**RE: Memorial Regional Hospital OR Expansion**  
**City of Hollywood, Florida**  
File # 24-DP-38  
RAI Response Letter

Per comments from June 17, 2024 regarding the above-referenced project, we offer the following responses:

**Exhibit 4  
Phasing Plan**

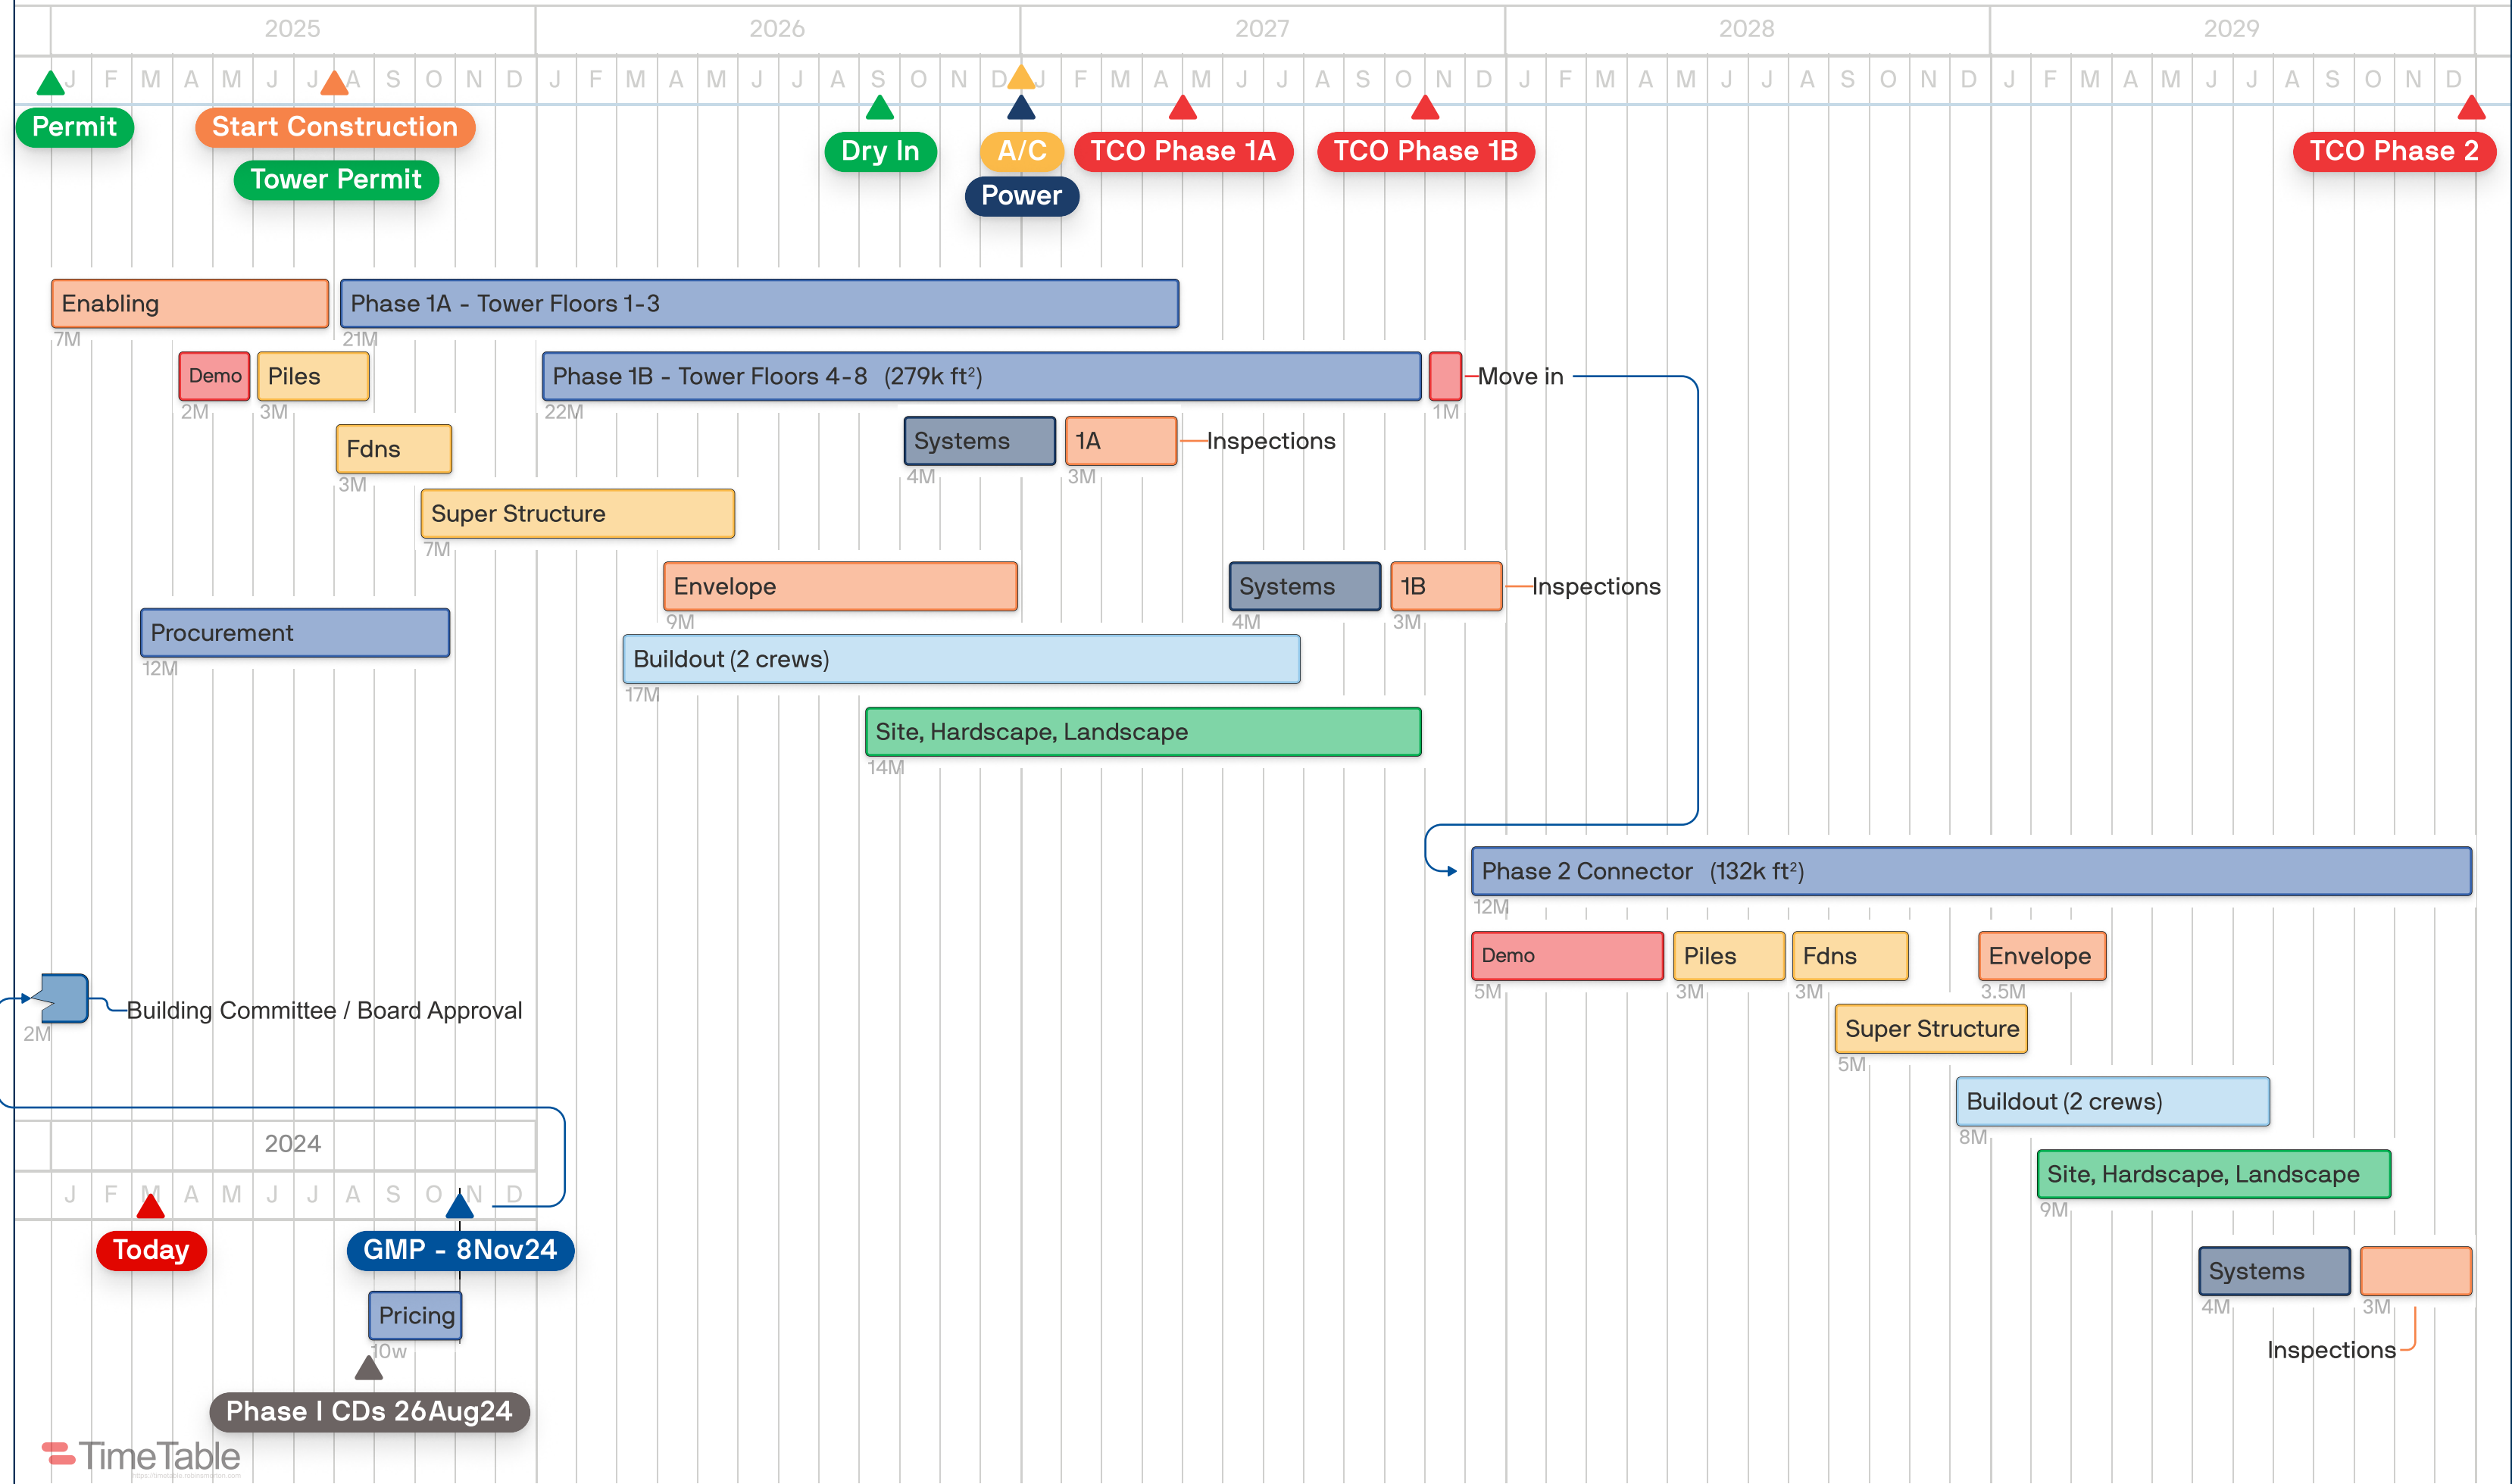
1. The Master Plan – Phasing Plan Phase 3 (E) notes the 8-story expansion to be 110,000SF, please confirm if this reference is to the proposed expansion of this application. If so, this line will need to be updated through an amendment of the ILA.

***Response: See attached updated and amended Exhibit 4 of ILA to reflect the expansion.***

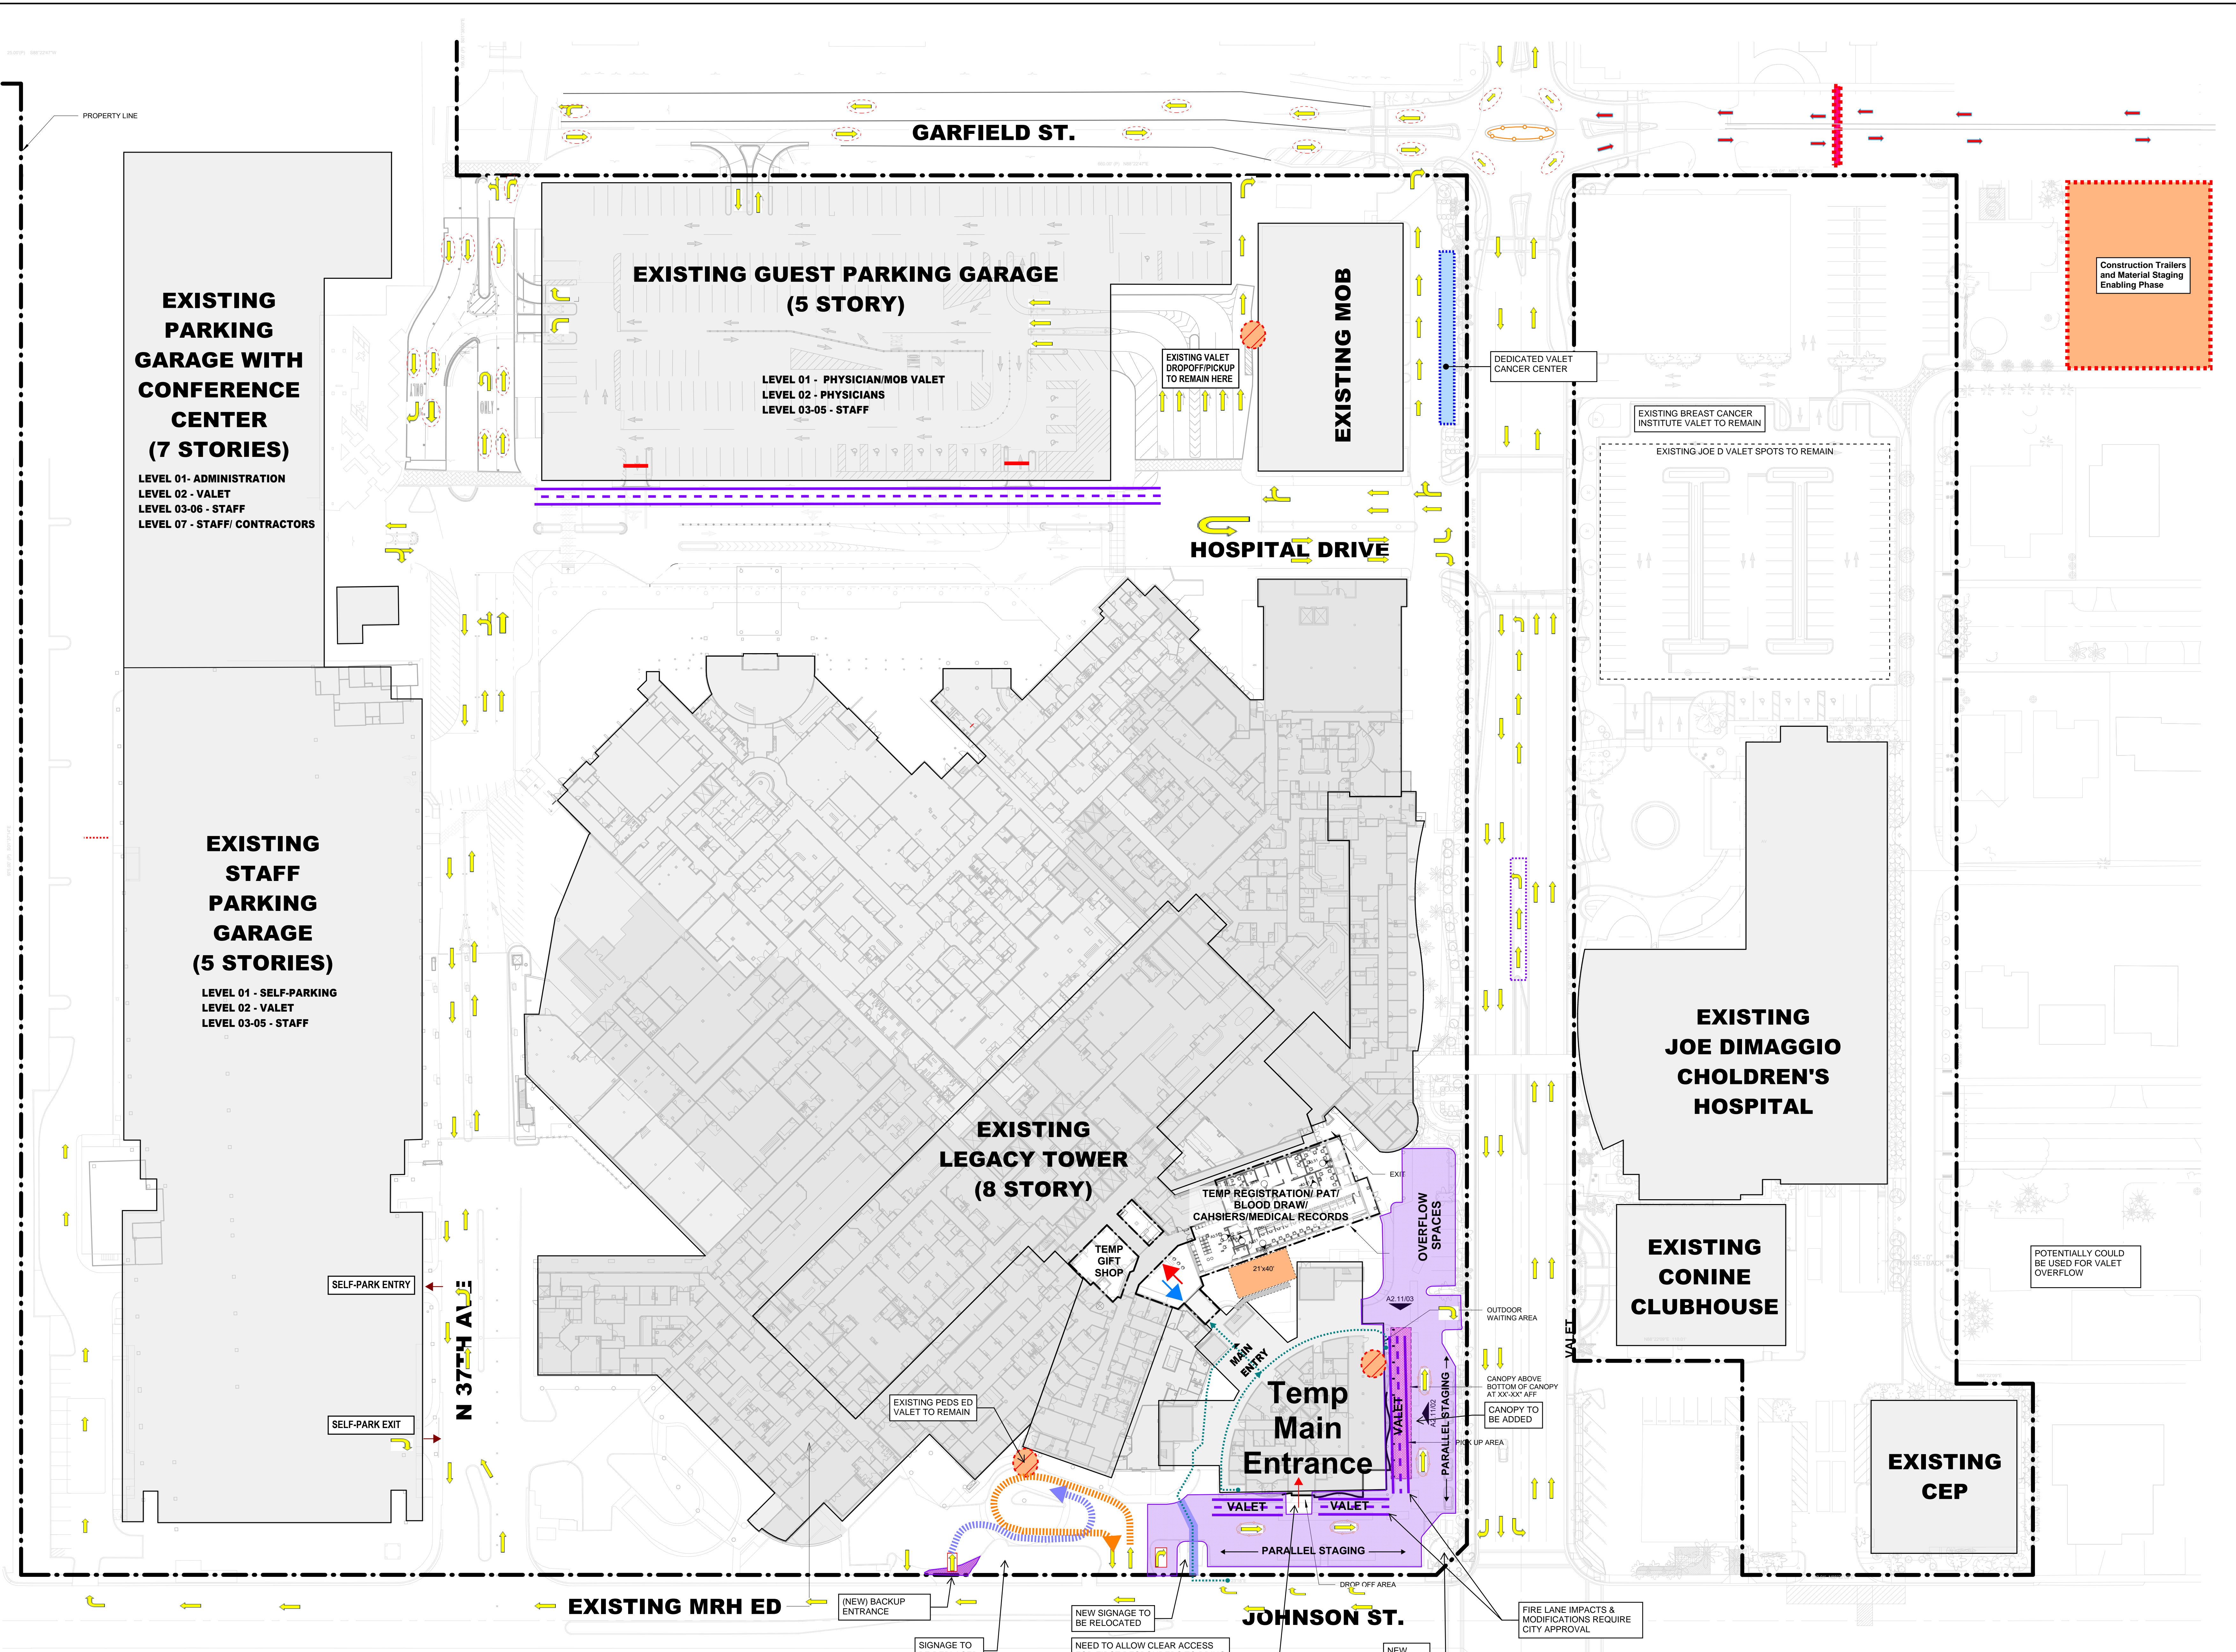
**Reviewer Response: COMMENT PARTIALLY ADDRESSED:** Note added onto Utility Plan Sheet C06 states 'Water and Sewer demands for this project have been calculated by the MEP Engineer to be 430 GPM', but no calculations were shown to substantiate. Please clarify if this is only for the addition. Verify 430 GPM = 619,200 GPD.\*\*

**Response:** Building expansion water consumption is estimated at an average of 450 gallons per minute. Calculation is based on plumbing fixture units accounting for usage diversity. The building expansion air conditioning is estimated to increase cooling tower make up water consumption by approximately 50 gallons per minute. Combined average consumption increase is estimated at 500 gallons per minute. See attached Building Expansion Water Consumption Calculations to substantiate demand calculations.
